Board of County Commissioners - Staff Report

Meeting Date: September 15, 2026 **Submitting Dept:** Planning & Building Services
Presenter: Chandler Windom **Agent:** Amberley Baker
Property Owner: JHHR Holdings I, LLC
Subject: DEV2026-0002 Northern South Park Area I Development Plan

A Development Plan pursuant to Sections 8.3.2 and 4.5.1 of the Land Development Regulations (LDRs) for a Master Site Plan in Area 1 of the Northern South Park Incentive Overlay.

Figure 2: Reduced Crossing Distance at Alleys

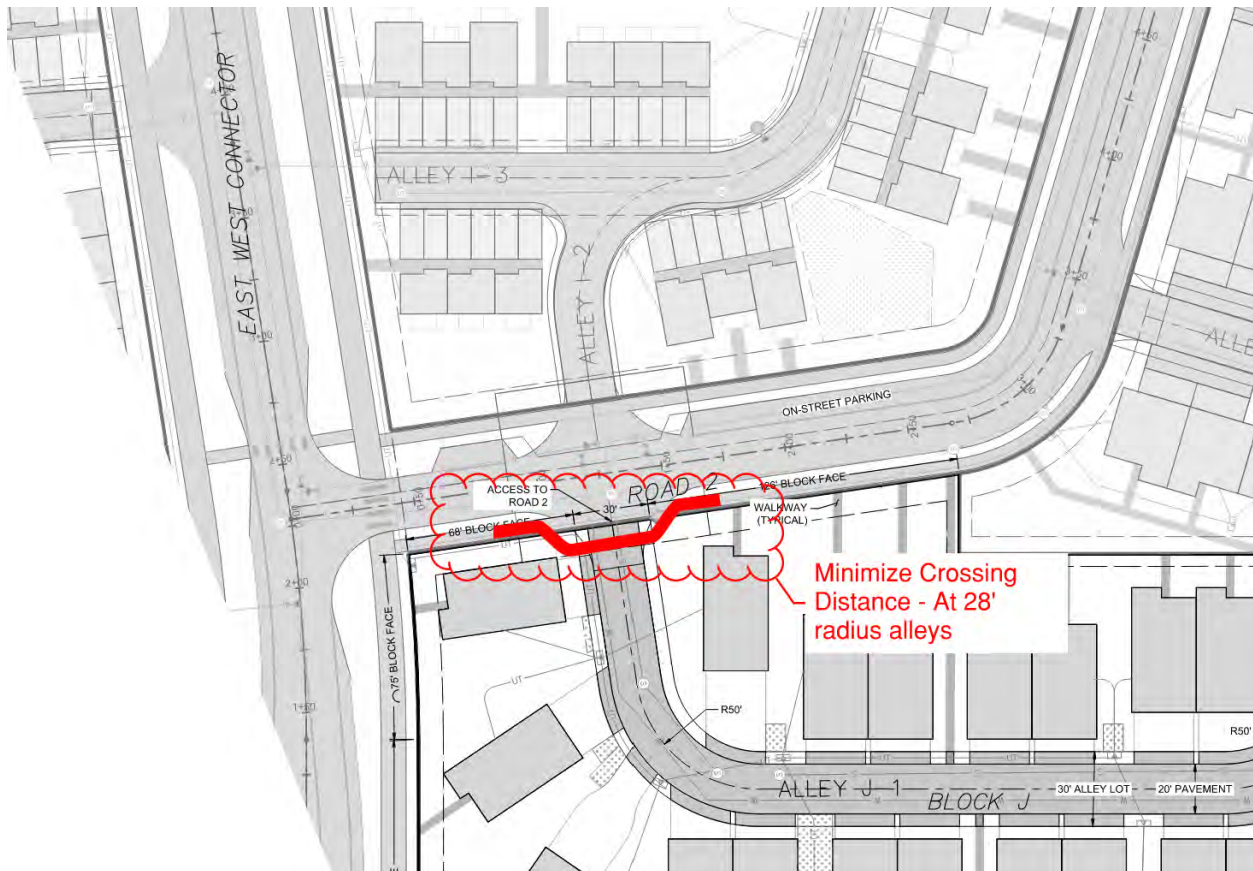
4. Crossing Distances and Curb Radii - See AASHTO 2024 Bike Guide Section 5.10.

- b. **Curb “Slivers”** – Numerous locations where there are relatively tiny slivers of curb on the corner radius, such as the NE corner of the Haystack and Road 1 intersection on Sheet ROW C4.4. If not elevated at full curb height in conjunction with an elevated pathway/sidewalk crossing, then there will be a constant problem of vehicles

Figure 1: Pathway curve radii

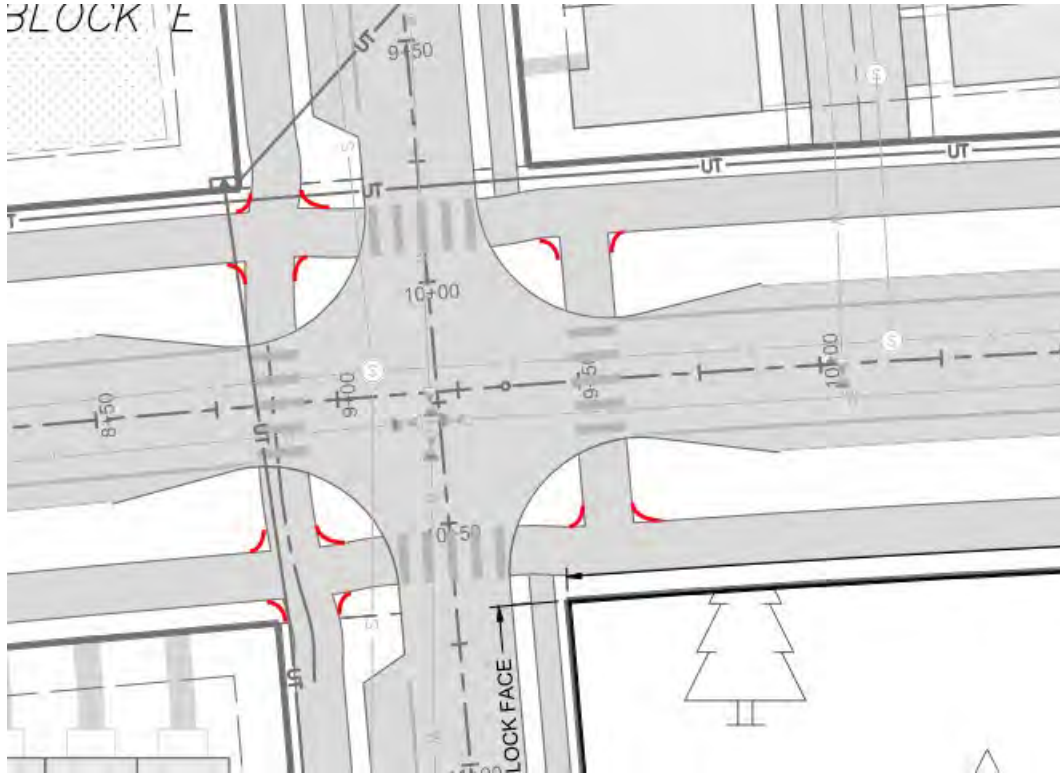
- a. **Corner Radius and Protected Intersections** - AASHTO 6.7.4 (intersection of 2 pathways) and 7.9.7 (Protected Intersections)

- b. Where pathways intersect with one another (generally at major intersections along Haystack and the E-W Connector), a radius should be provided for the pathway corners. These intersections should be designed essentially as **protected intersections** to facilitate a higher level of safety at these busier intersections. Staff can provide additional design guidance and resources as needed.
- c. Pathway alignment along JH Hereford Ranch Road (Block N) on Sheet ROW C4.9. The diagonal orientation should mirror the alignment and offset on the approach to Road 3 that the pathway in Park 6 follows. (Copy the Park 6 Pathway alignment onto the leg south of Road 3).

Figure 2: Multiple threat crossing intersection

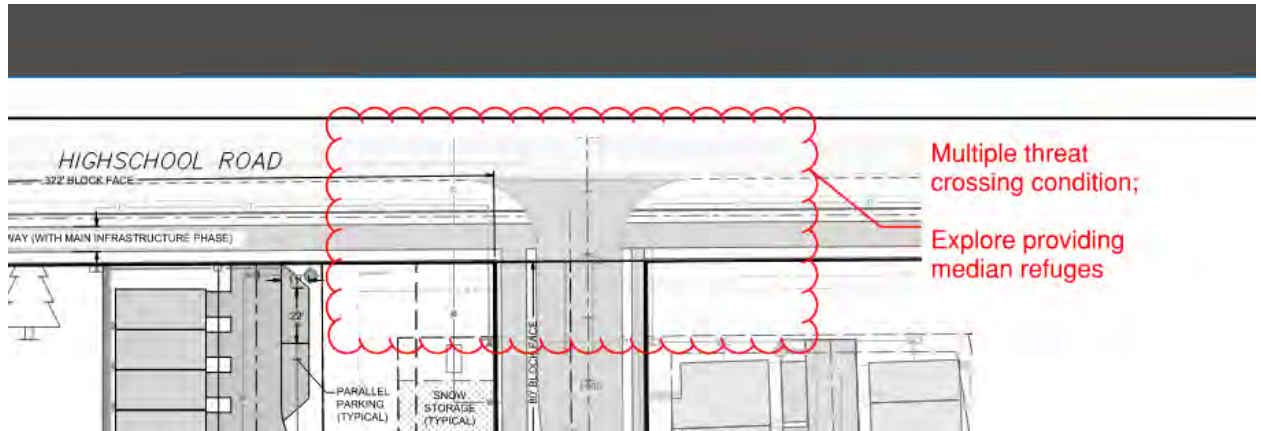
- a. Where pathways running parallel to HS Road and S Park Loop intersect with Haystack and the E-W Connector respectively, additional measures needed to improve bike/ped visibility at 3-lane road crossings to avoid multiple-threat crossing condition. Please address double threat conflicts. Please evaluate pedestrian/cyclist refuge islands, turn lane elimination, etc.
